Re: Notice of Planned Change – East Ash Pond Excavation Stormwater Management Phasing Plan
Virginia Pollutant Discharge Elimination System (VPDES) Permit No. VA0004138
Dominion – Bremo Power Station

RE: Dominion Bremono Power Station VPDES Permit No. VA0004138:
Revised Notice of Planned Change

EAST ASH POND EXCAVATION STORMWATER MANAGEMENT PHASING PLAN

FIGURE 3

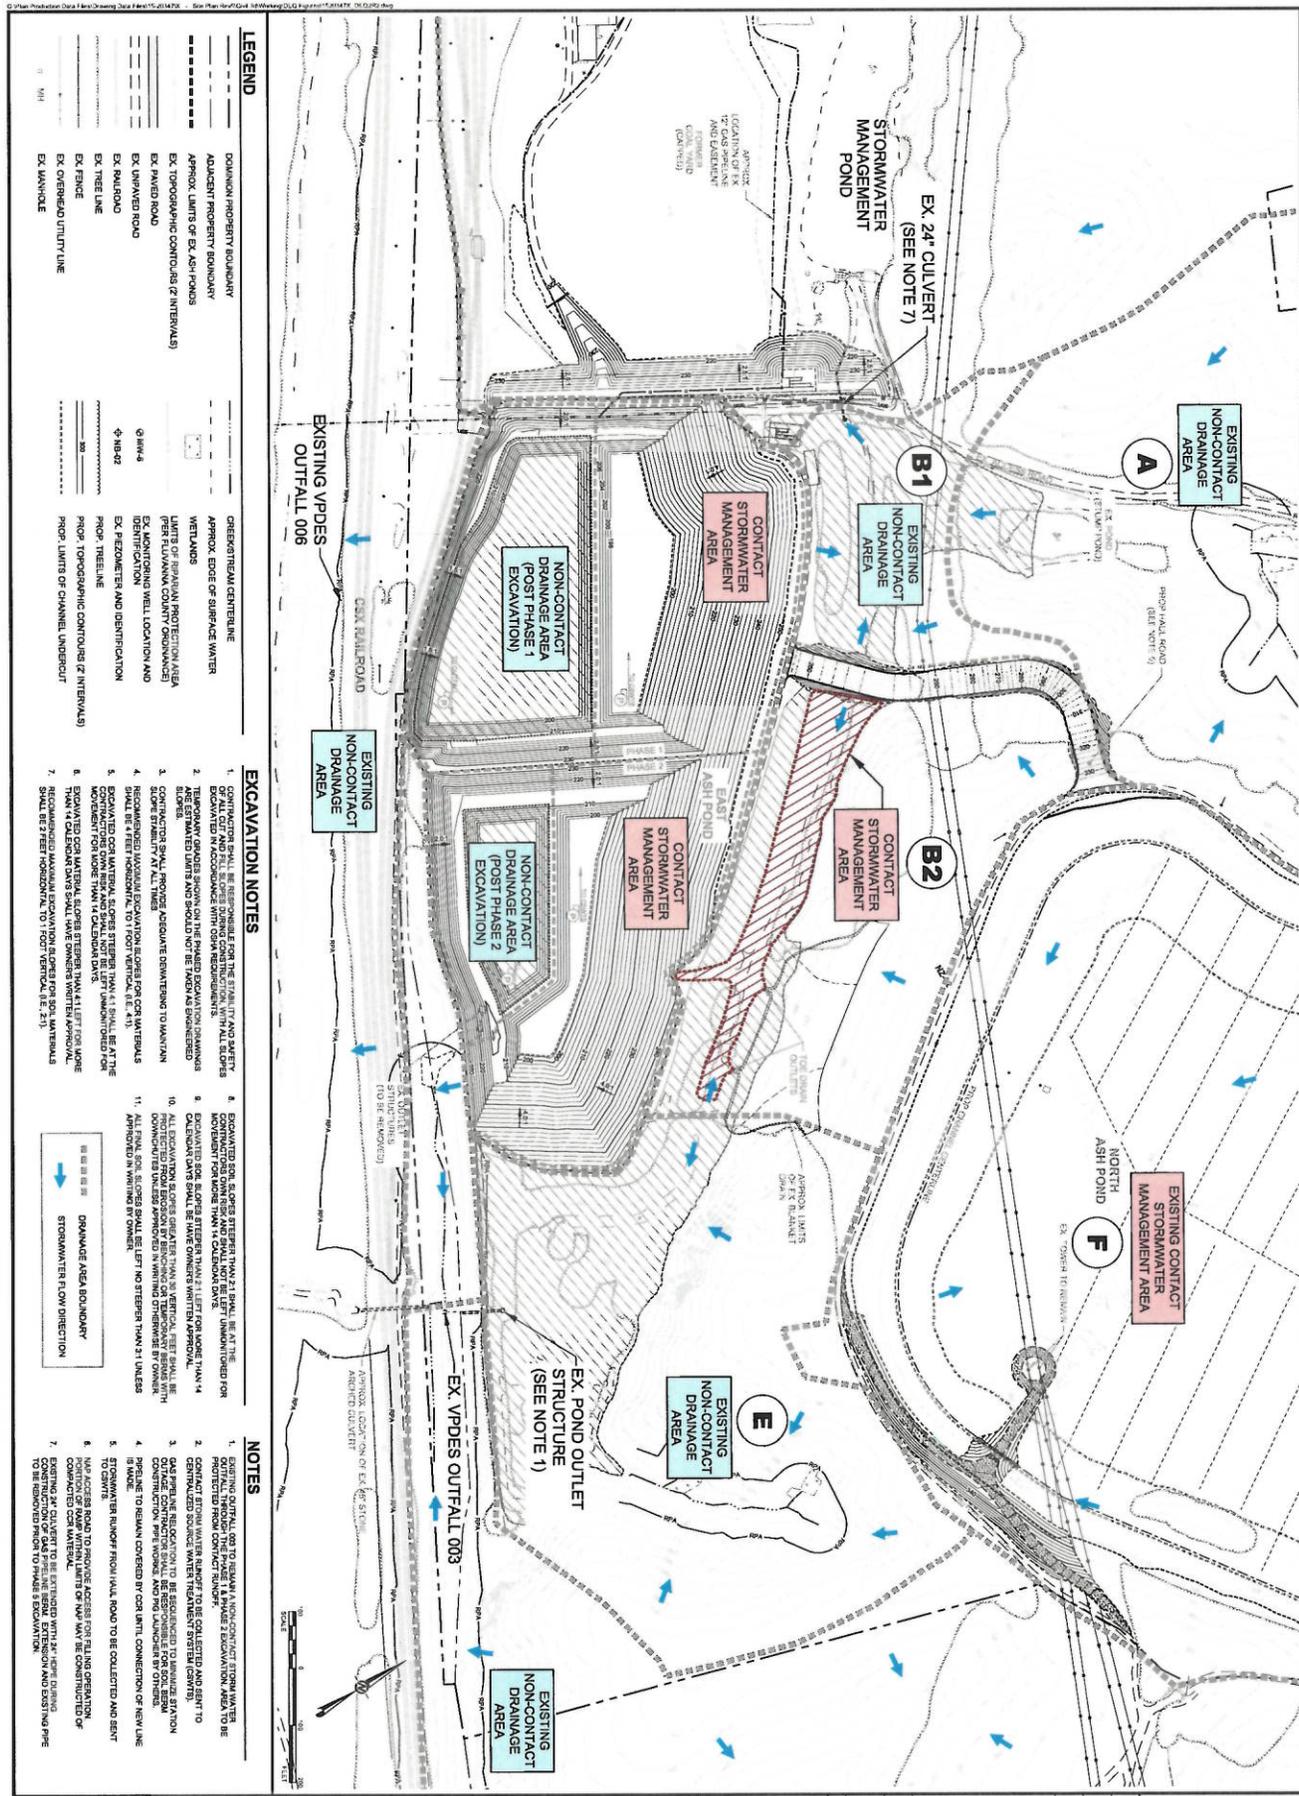
Figure 3 depicts the result of alternating CCR excavation between Phases 1 and 2 until both phases are complete. An existing non-CCR soil splitter dike will separate the Phase 1 and Phase 2 locations after CCR excavation, and each phase area will be separated into CCR contact and non-contact stormwater management areas by the construction of additional berms using clean fill material. The CCR contact stormwater will be pumped to the CSWTS for treatment prior to discharge through Outfall 504. The non-contact stormwater drainage areas will be temporarily lined, and the collected stormwater will be pumped to Outfall 006, Outfall 003, or the existing Stormwater Management Pond. Stormwater may also be pumped from one temporary lined area to another for management purposes.

Prior to the initiation of CCR excavation activities, a haul road will be constructed connecting the NAP and the EAP. The road will be graded to divert stormwater that contacts the road to a designated contact stormwater management area located in Area B2. The contact stormwater will then be pumped to the CSWTS.

Non-contact stormwater will continue to drain from the existing non-contact drainage areas containing the stump pond and adjacent to the connecting NAP and EAP haul road (Areas A and B1, respectively) to the Stormwater Management Pond.

The NAP toe drain water will continue to drain into Area B2 and ultimately discharge into the contact stormwater management area and be pumped to the CSWTS.

Non-contact stormwater from Area E will continue to drain into the existing non-contact Outfall 003.

FIGURE 5

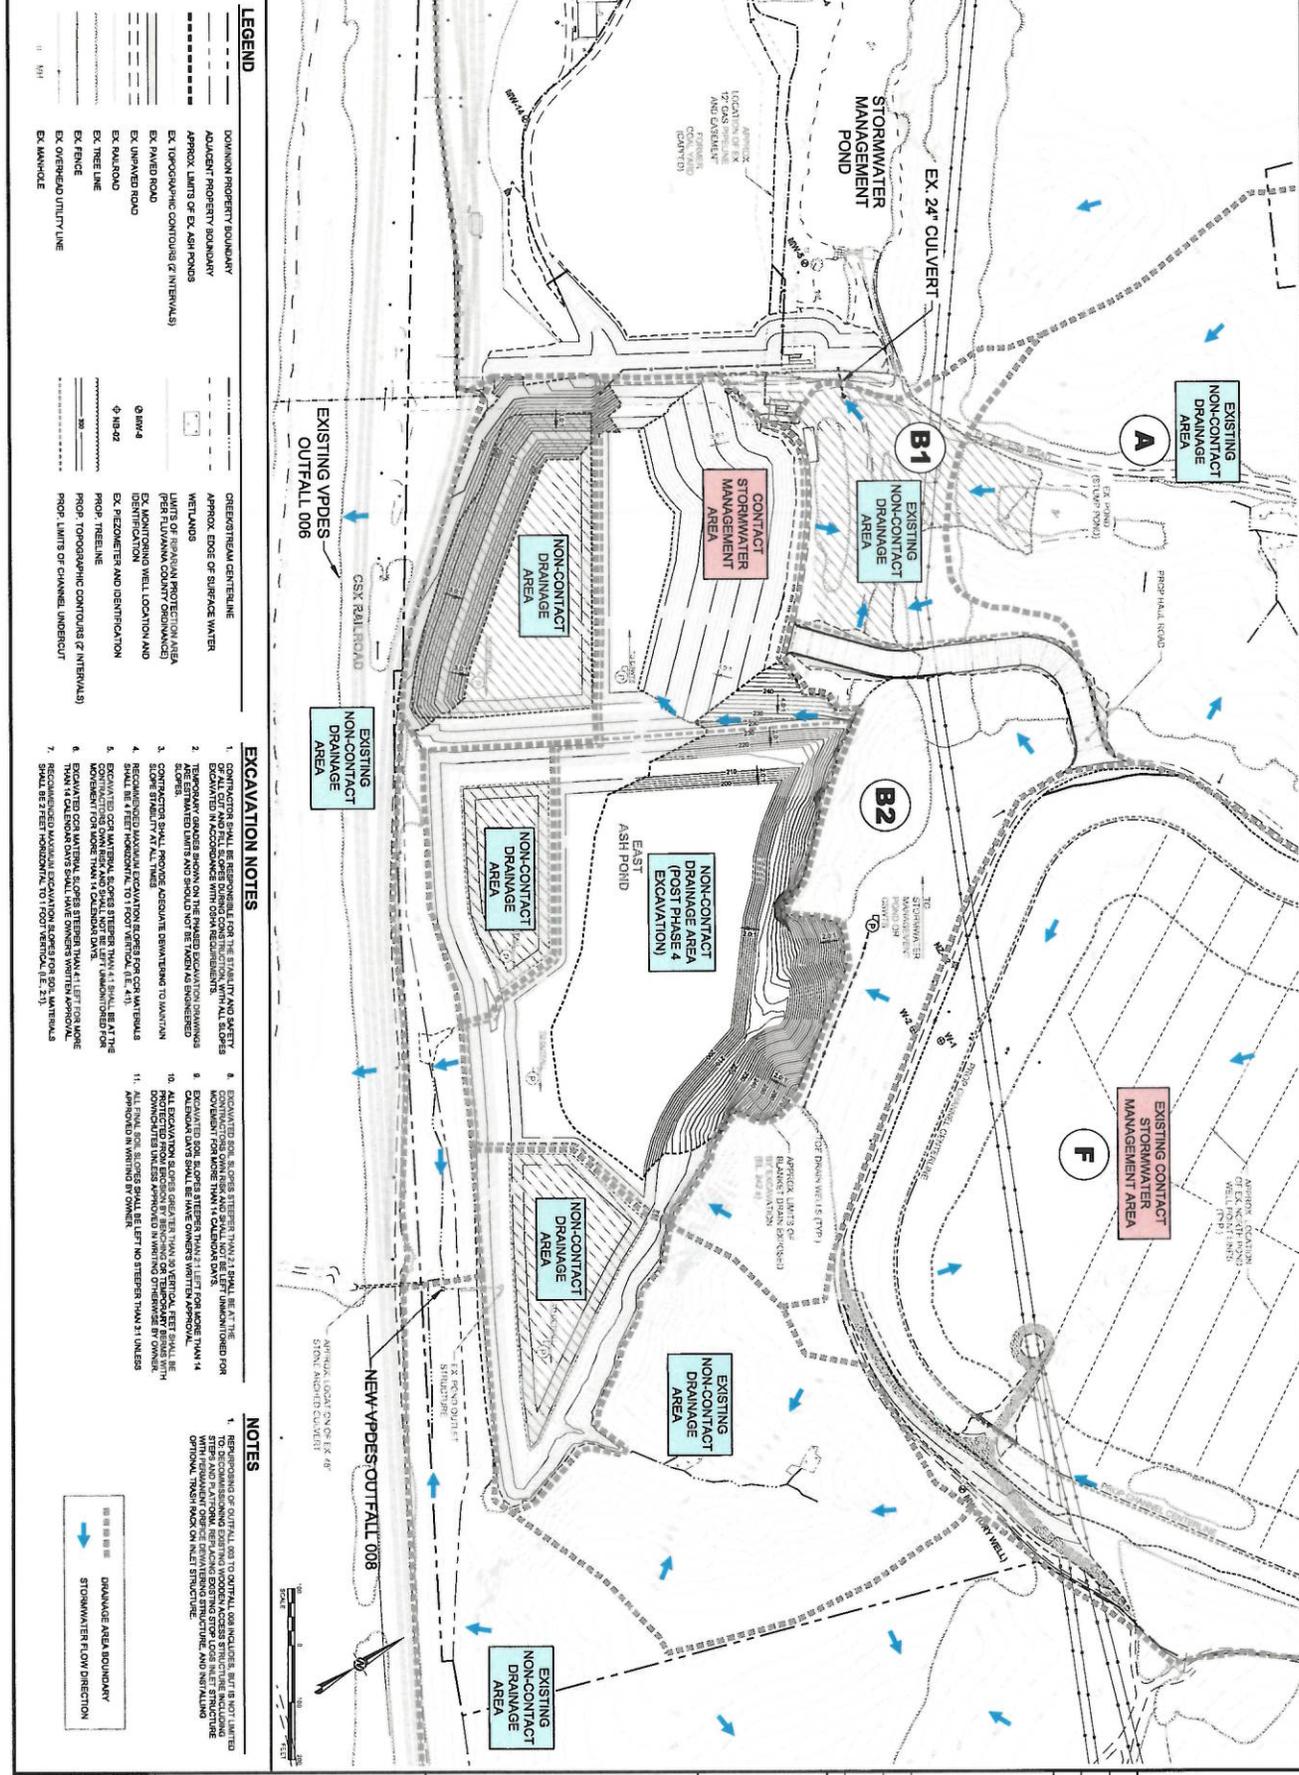
Figure 5 depicts the CCR removal in the Phase 4 area as well as the toe excavation of the NAP. Soil excavated from the NAP toe will be used to shape the final side slopes of the non-contact drainage area created in Phase 1. During excavation activities, CCR contact stormwater will be pumped to the CSWTS to be treated prior to discharge through Outfall 504. After the excavation and CCR removal, the former CCR contact stormwater management areas created by Phases 2 and 3 will be expanded by Phase 4 and become a non-contact drainage area. The northwestern corner will use the existing soil splitter dike as the drainage divide between the CCR contact stormwater management area created by Phase 1 and the non-contact drainage areas to the east of the splitter dike. Stormwater in the non-contact drainage areas may be pumped to Outfall 006, 008, or the existing Stormwater Management Pond. Stormwater may also be pumped from one temporary lined area to another for management purposes. The road's CCR contact stormwater will continue to drain into a CCR contact stormwater management area created during Phase 1.

Non-contact stormwater will continue to drain through the existing drainage areas A and B1.

The NAP toe drain water will cease to drain during excavation of the NAP toe through installation of a series of toe drain wells installed on the NAP embankment. The toe drain water will be pumped to the Stormwater Management Pond or CSWTS for treatment prior to discharge.

Phase 4 excavation may begin during the Phase 3 excavation in preparation of the North Ash Pond Embankment toe excavation.
